RECORD COPY				DATE ENTERED		DATE		INITIALS	
File Name <u>Keokuk - Sewage</u>						<u>6/2/87</u>		<u>JME</u>	
DATE RECEIVED	SENDER'S NAME	COUNTY NO.	PROGRAM AREA CODE	FACILITY TYPE CODE		SUBJECT AREA CODE			
<u>5/12/87</u>	<u>City of Keokuk</u>	<u>56</u>	<u>CP</u>	<u>CO1</u>		<u>305</u>			
RULE REFERENCE	DESIGN STANDARD REFERENCE		DECISION			APPEAL ACTION			
<u>9</u>	<u>12.5.1</u>		<u>11 Approved</u>			<u>12</u>			
			<u>6/2/87.</u>						
ENGINEER			VARIANCE RULE						
<u>13 Shoemaker & Haaland</u>			<u>14 64.2 (9) C</u>

CONSTRUCTION PERMIT

RE: Office Building Sewer

190 feet of 8-inch and 12 feet of 6-inch sanitary sewer (P.V.C.) and appurtenance,
Professional Office Building Sanitary Sewer Extension, City of Keokuk, Iowa.

Shoemaker & Haaland Professional Engineers				Shoemaker & Haaland	
Corollaries Keokuk Cedar Rapids				SANITARY SEWER	
SURVEY	DRAWN	CHECKED	APPROVED	DATE	SCALE
RLS	FMB			26 MAR 07	AS SHOWN

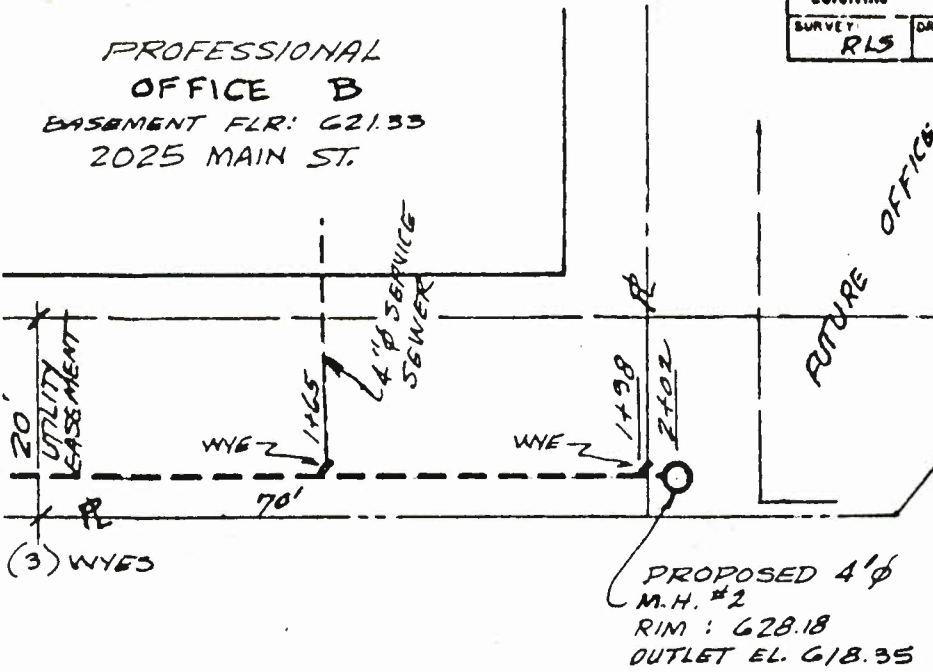
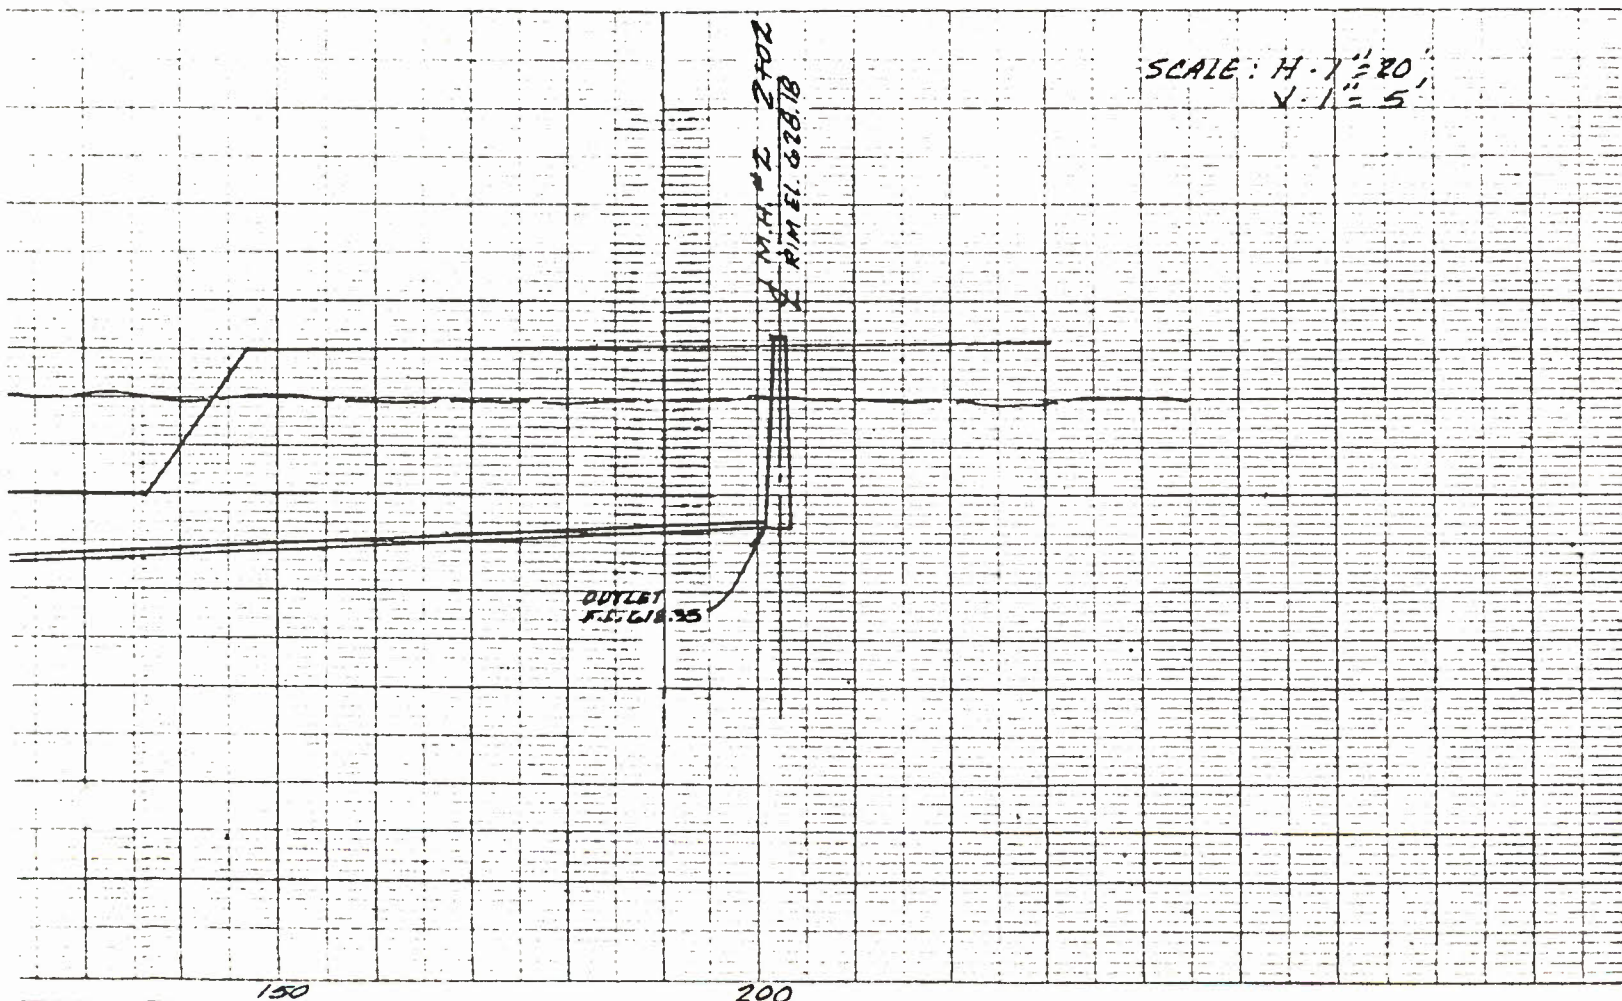
Proposes new 8" S.S.E. in Main St. @
2.32% slope - connection from MTH#
to existing 6" sewer is proposed
as 6" diameter sewer - length = 12 ft.
and slope = 12%

Existing 6" sewer has length of 180 ft.
- discharges into a 5 ft x 4 ft concrete
box main combined sewer. Engineer
advises that the sanitary sewer
extension is in such a location that
future extension would not be practical
or necessary since the surrounding
area is already sewered. Engineer
advises that City has a sewer jet
machine which is capable of cleaning 6" line.

($V = 4.3$ fps)
Flowing full capacity of 8" sewer @ 2.32% = 1.10 MGID
Flowing full capacity of 6" sewer @ 12.0% = 1.89 MGID

The requested variance from our design standards to permit the use of 6-inch diameter sewer for connection to the existing sanitary sewer system is hereby granted.
